Voting Results on T10Letter Ballot 02-376r0 on
 Forwarding PIP to First Public Review
 Ballot closed: 2002/10/17 12:00 noon MDT

PIP Comments

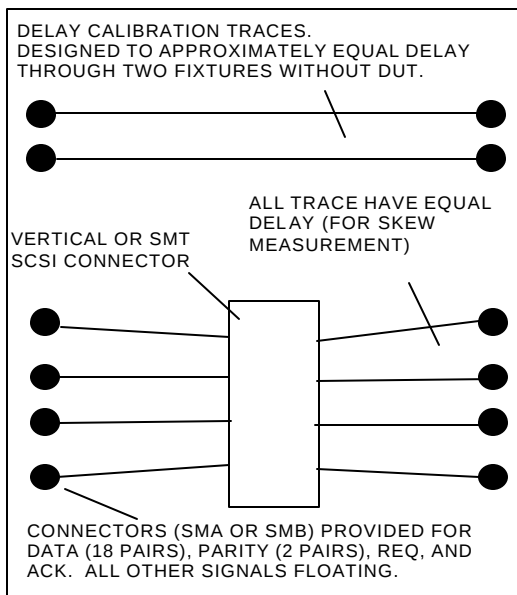
Comment number: 12 T

Document location: 7.7.2.5

Comment: a) Would like to see a WARNING to be sure probe polarity of victim signal not inadvertently reversed.

b) Do we want to correct stored trace section to show 18 aggressors? Presently we show 25.

Proposed resolution: rendered irrelevant by previous comment resolution.

Improved Figure C.2 (from PowerPoint)

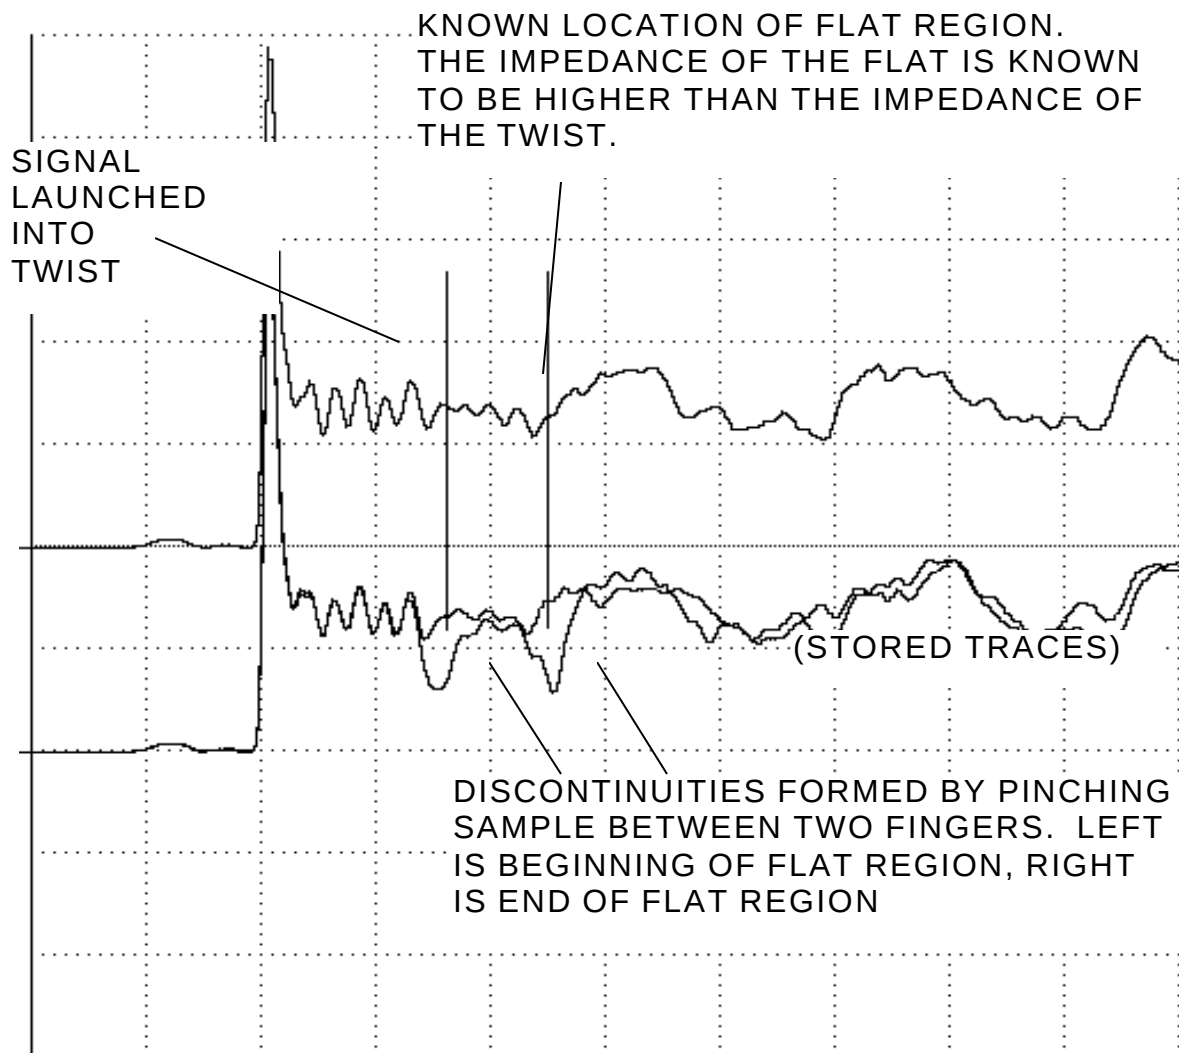
Comment number: 38T

Document location: Figure C2

Comment: Use improved figure below

Accepted, changed

Improved Figure C.3 (from PowerPoint)

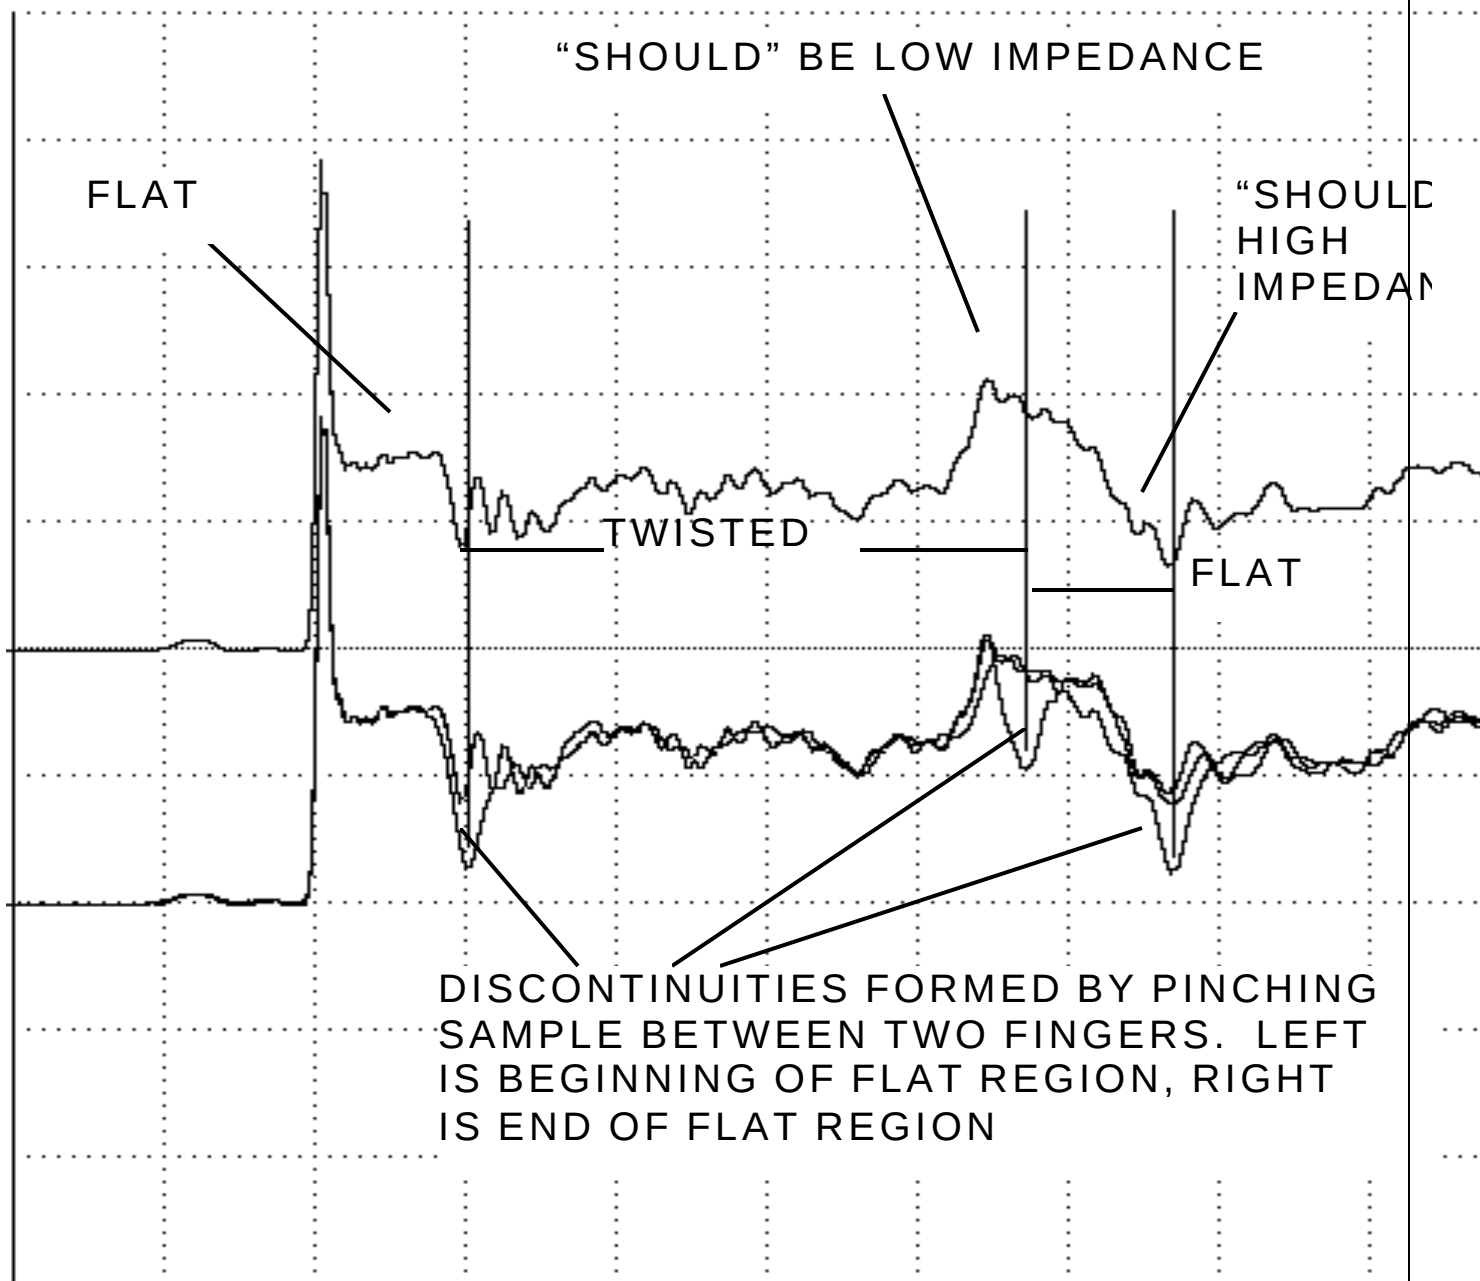
Comment number: 39T
Document location: Figure C.3
Comment: use improved figure below
Accepted, changed
